APPLICATION NO.	FILING DATE	FIRST NAMED INVENTOR	ATTORNEY DOCKET NO.	CONFIRMATION NO.	
10/657,699	09/09/2003	Filiep Vanthournout	KOB 8755		
7590 . 07/14/2005			EXAMINER		
James C. Wray			SUTTON, ANDREW W		
Suite 300 1493 Chain Bri	idge Road	ART UNIT	PAPER NUMBER		
McLean, VA 22101			3765		
			DATE MAILED: 07/14/2005

DETAILED ACTION

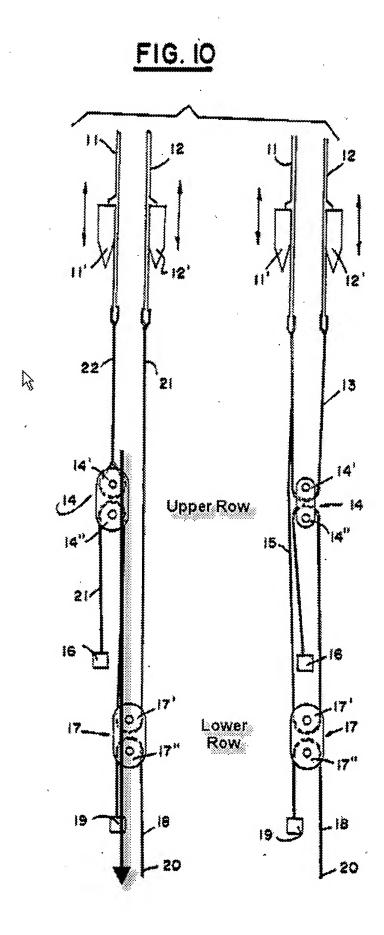
As to claim 2, Derudder illustrates (Fig. 10 and 11) first set of hooks 11 operating in conjuctions with the first pulley 14 in the upper row and hooks 12 operating in conjuctions with the second pulley 17 in the lower row. From the illustration below you can see that pulleys 14 and 17 would overlap each other when projected on the horizontal plane downward.
